From: [INFOCNTR \(PHMSA\)](#)
To: [Baker, Yul \(PHMSA\)](#)
Cc: [Hazmat Interps](#)
Subject: Written Interpretation Request
Date: Thursday, October 9, 2025 13:47:09
Attachments: [image001.png](#)
[GIRARD VALVES \(1\).pdf](#)

From: Rod.Moser@puco.ohio.gov <Rod.Moser@puco.ohio.gov>
Sent: Wednesday, October 8, 2025 10:37 AM
To: PHMSA HM InfoCenter <PHMSAHMInfoCenter@dot.gov>
Cc: Bradley.Long@puco.ohio.gov; Michael.Barker@puco.ohio.gov
Subject: Written Interpretation Request

DOT 407 Combination Pressure/Vacuum Relief Vent

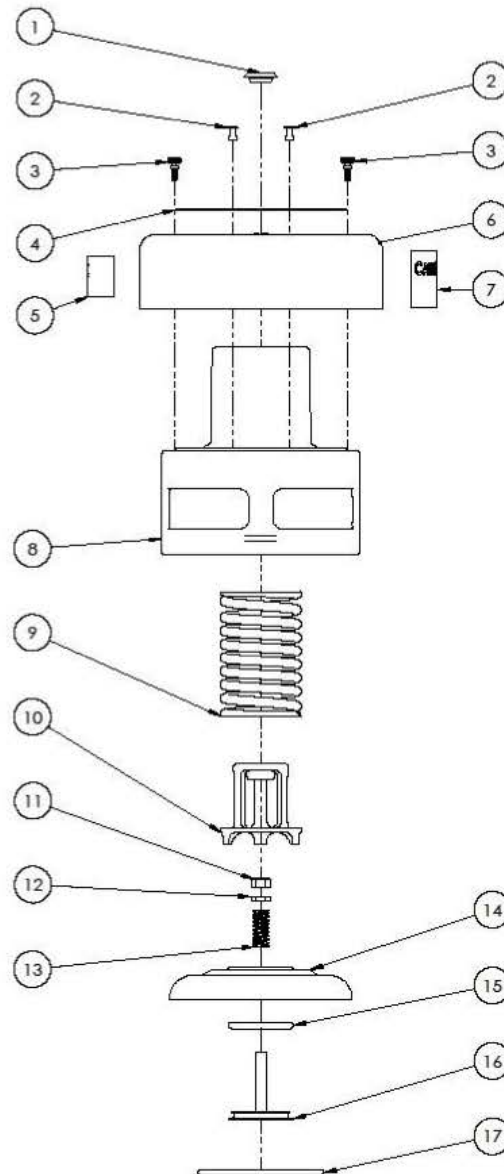
1. What part of the PRD is this sub-section referring to ? Is it referring to the “rain cap” specifically or any portion of the PRD in general ? For instance, if a rain cap retaining screw was found to be missing would that also constitute a violation ?
2. Does the lack of a rubber “upper housing hole plug,” shown as Item #1 on the

attached schematic for a Girard 407 PRD, constitute a violation of 178-345-10 sub-section (b)(6) in regard to protecting the device from “freezing, corrosion, or blockage?”

3. If the rain cap is in place but the rubber plug is missing is this a violation ?
